MENN TRACT PRELIMINARY OVERALL AREA DEVELOPMENT PLAN

Re: Menn Tract

POADP # 718

The City Staff Development Review Committee has reviewed : Menn Tract Master Development Plan (M.D.P.) formerly (POADP) # 718. Please find enclosed a signed copy for your files. Your plan was accepted, however please note the following:

PRELIMINARY OVERALL AREA DEVELOPMENT PLAN

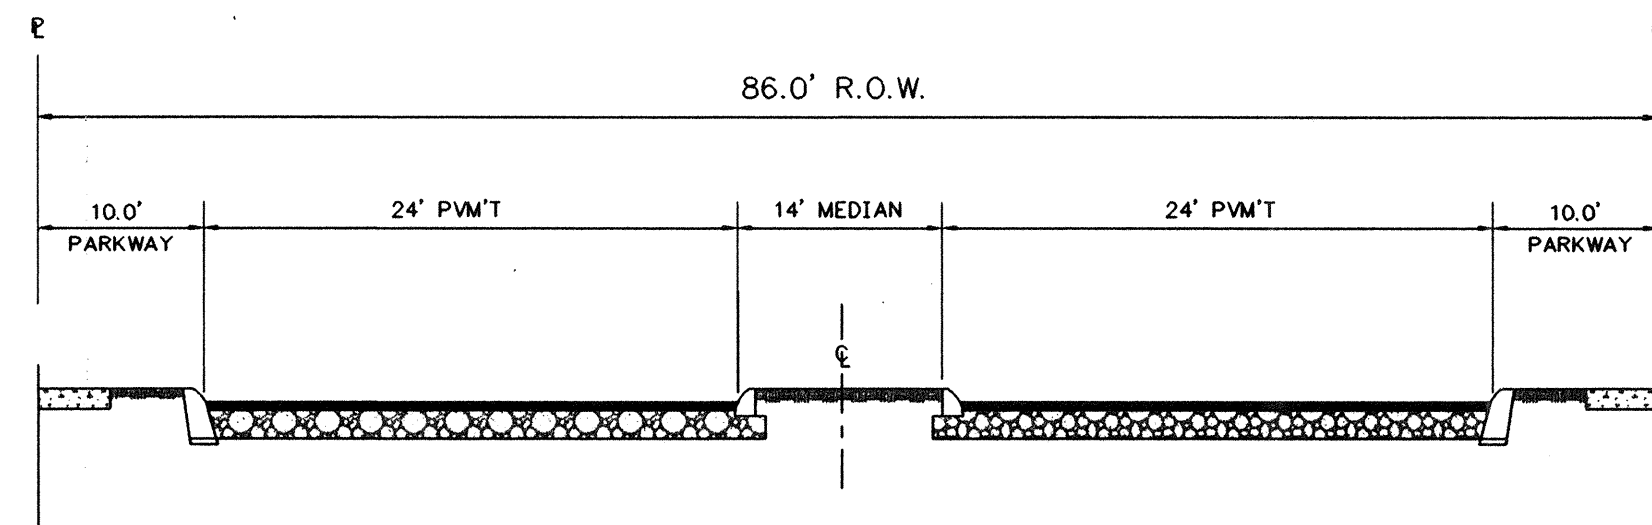
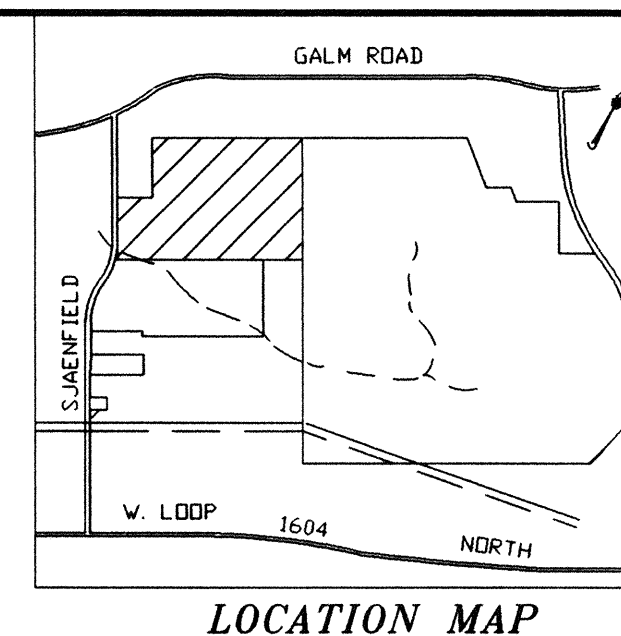
Pending on the following comments:
-(Unit 4) Identify the location of the FEMA
100 year Flood plain.
- Verify scale along Shaenfreid Rd.
- Location of street and lots will impact evaluation
of traffic on local "B" street

Comments: SHAENFIELD ROAD IS ON THE MTP REQUIRING A MIN.
OF 86' ROW. PROPOSE POADP DOES ADDRESS THOROUGHFARE

DATE: 10/16/01
REVISION: ENTRY FLARE DETAIL
